# ATTACHMENT C

Department of Permitting Services  
Fire Department Access and Water Supply Comments

**DATE:** 02-May-20  
**TO:** Alan Barney - abarney@dewberry.com  
Dewberry  
**FROM:** Marie LaBaw  
**RE:** 12500 Ardennes  
820200080

Attn: Marie LaBaw  
RE: 12500 Ardennes Avenue; Statement of Performance Based Design  
820240060

TITLE: Fire Department Access Plan

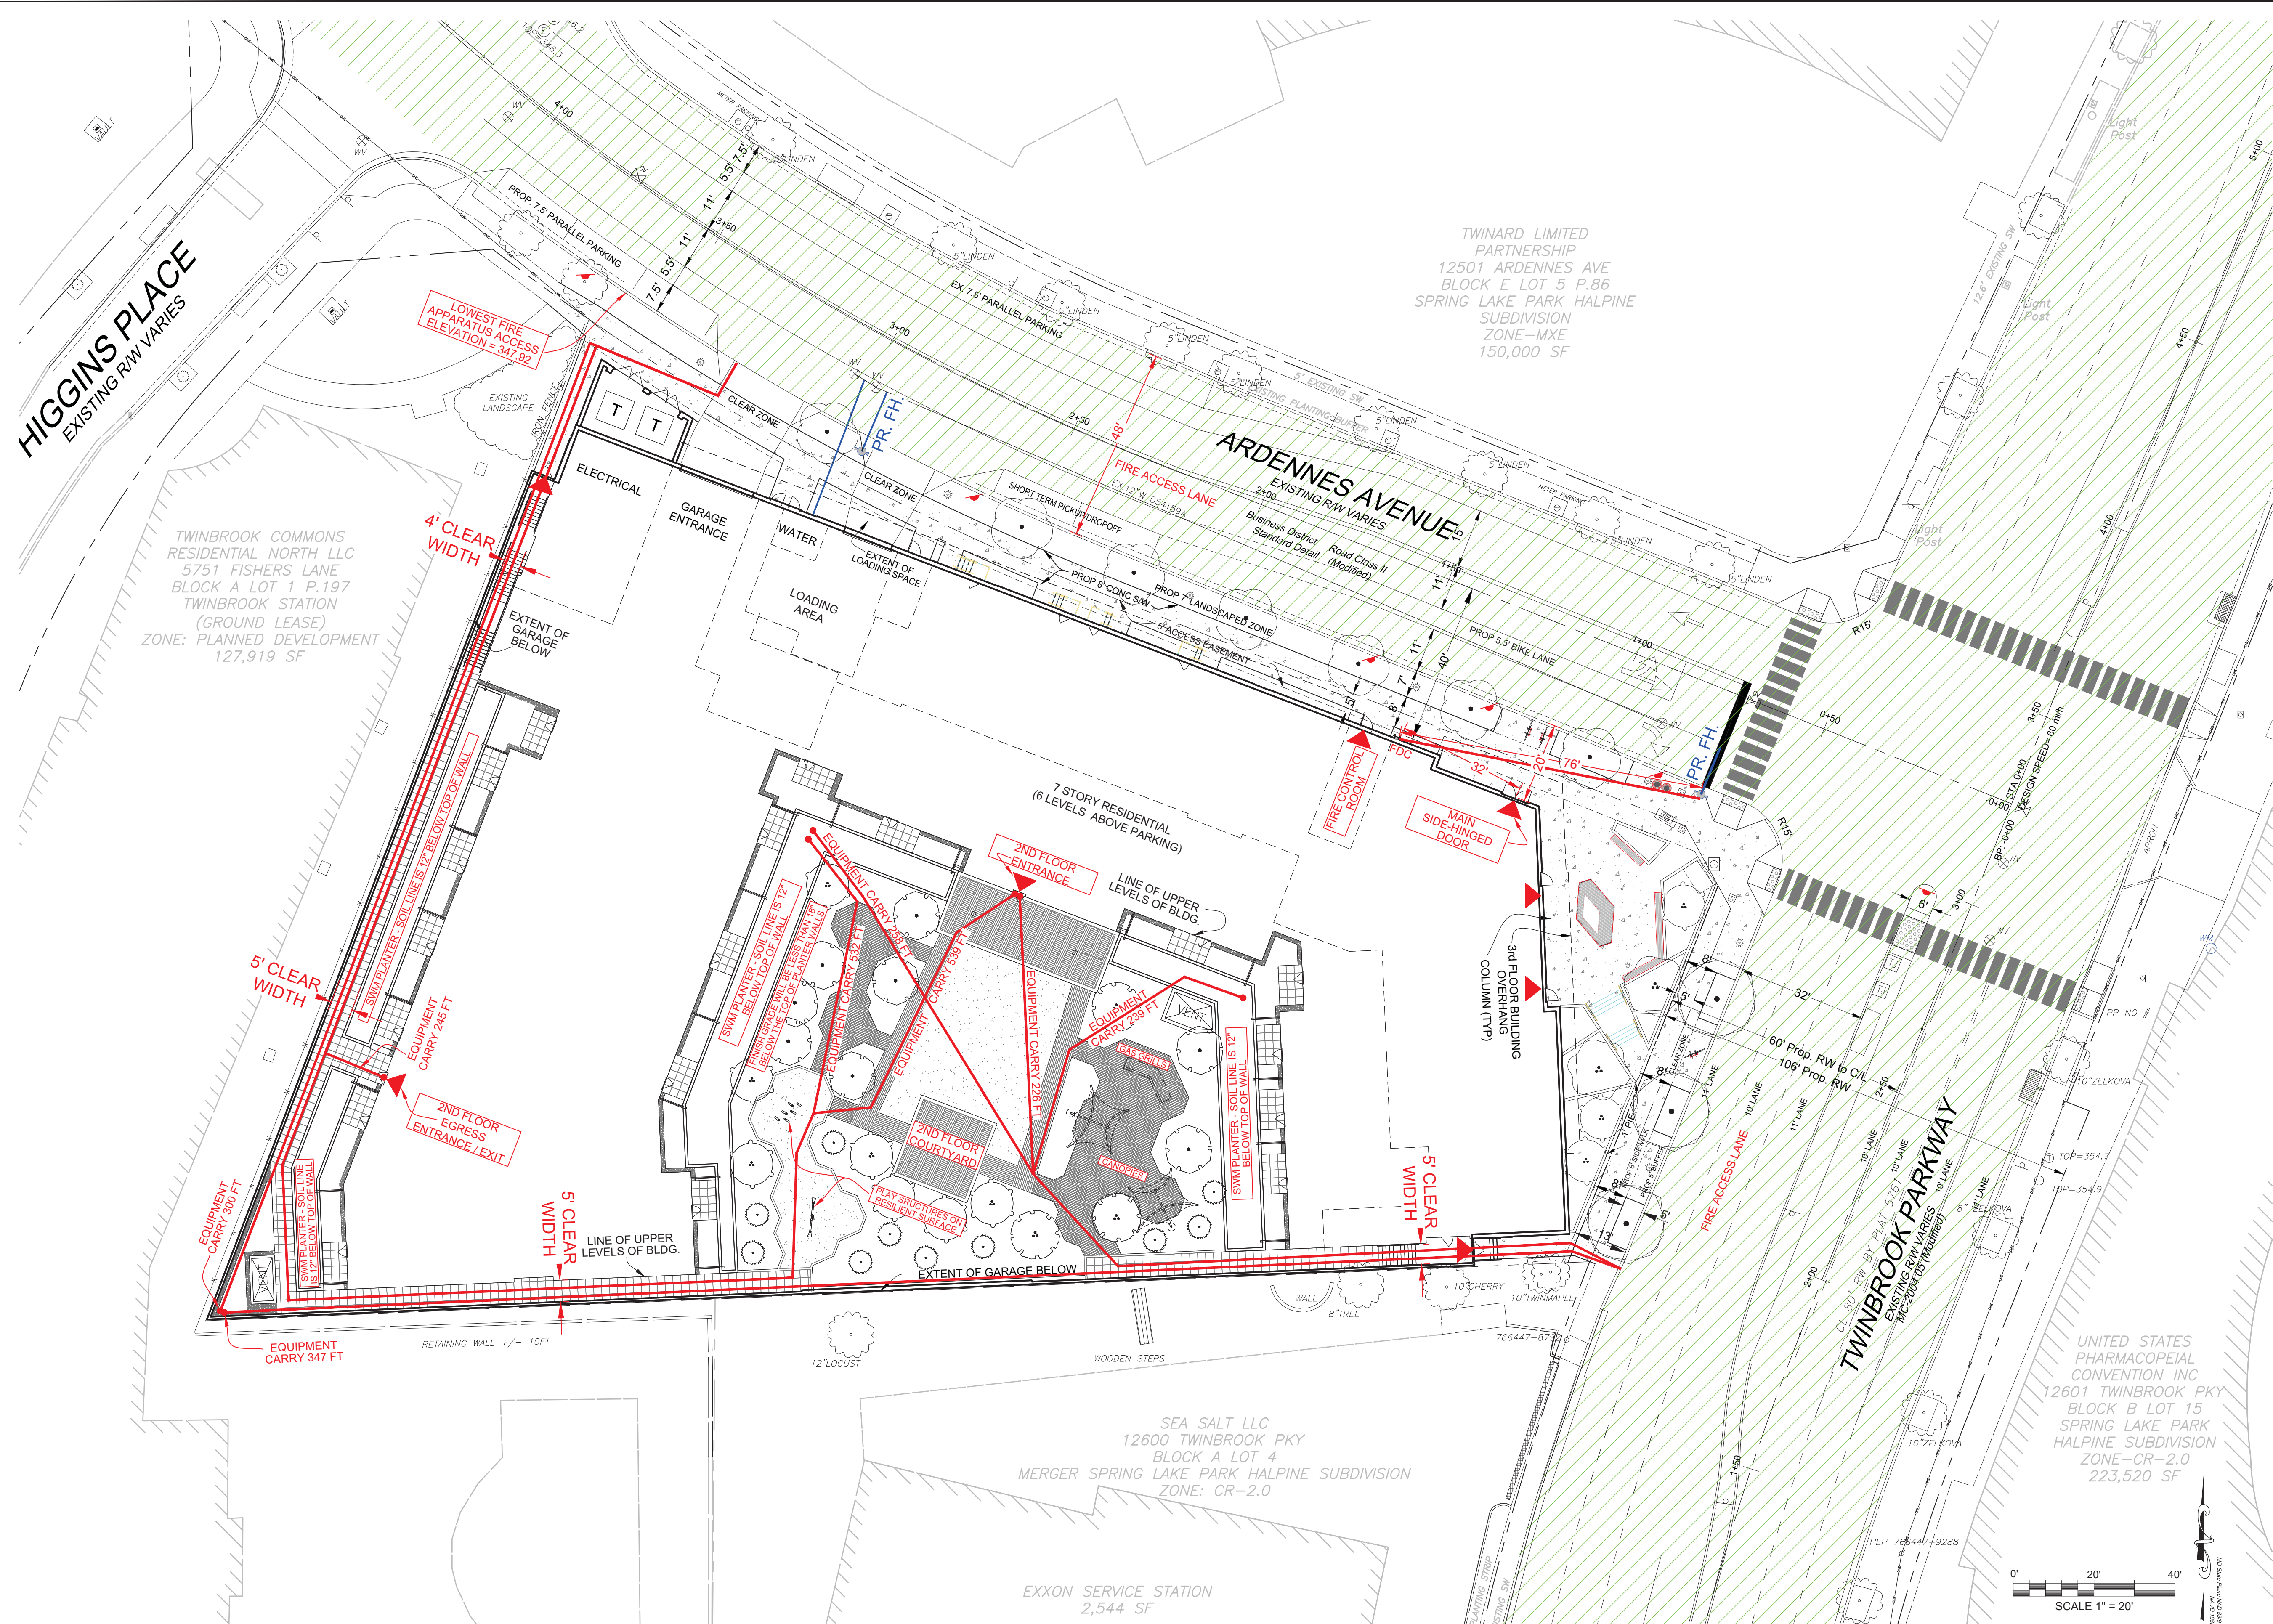
**Matters of Clarification:**  
**Item 1:** Montgomery County has amended Section 18.2.3.2.3.6 of NFPA 1 to require that every point on the exterior of a sprinklered building shall be within 450 ft of compliant FD vehicular access via a 15-foot-wide clear and walkable grade.

**Item 2:** Podium construction will require a fire command center. Provide schematic location at site plan to be finalized at building permit.

**Response:** The proposed building is less than 75' to the highest floor, with IIA construction above a 1A podium. However, the design of the building incorporates multiple Emergency systems as listed below. As we had discussed in our meeting, you had accepted the rear fire access path to be a minimum of 4' clear width between handrails, and since the building is equipped with automatic sprinklers, emergency egress from the windows is not required, and will be provided via two exit paths per floor. The SWM bio-planters are between 3' and 5' higher than the adjacent patio deck, and therefore not accessible. The planters do not block the fire response to the 2nd level entrances. The building has fire department access from two streets; and the minimum 4-foot clear width pathway and exterior stairs provide access to the rear of the building and podium level courtyard via two secured access points, one off each street, with a Knox box for fire department access. Emergency egress from the windows is not required per IBC Section 1006.2.1 where the dwelling unit is equipped with automatic sprinkler system per IBC Section 903.3.1.1 or 903.3.1.2 and provides access to two building exits per floor.

**Response:** A fire command center has been added to the ground floor, as shown on the Fire Access Plan, as required by IBC and Montgomery County Executive regulations.

- All storm water planters on the second level will be approximately 40 inches - 56 inches in height from finished grade.
- Thru access from these storm water planters to the building face is limited.
- Access to the SWM planters will be provided across the courtyard. The landscaping and grading in the community courtyard will be graded at less than 1:25 to provide a clear and walkable access. The ground will be less than 18" below the top of the planter walls around the full perimeter of the community courtyard.
- Vegetation inside the SWM planters will be less than 18" high.
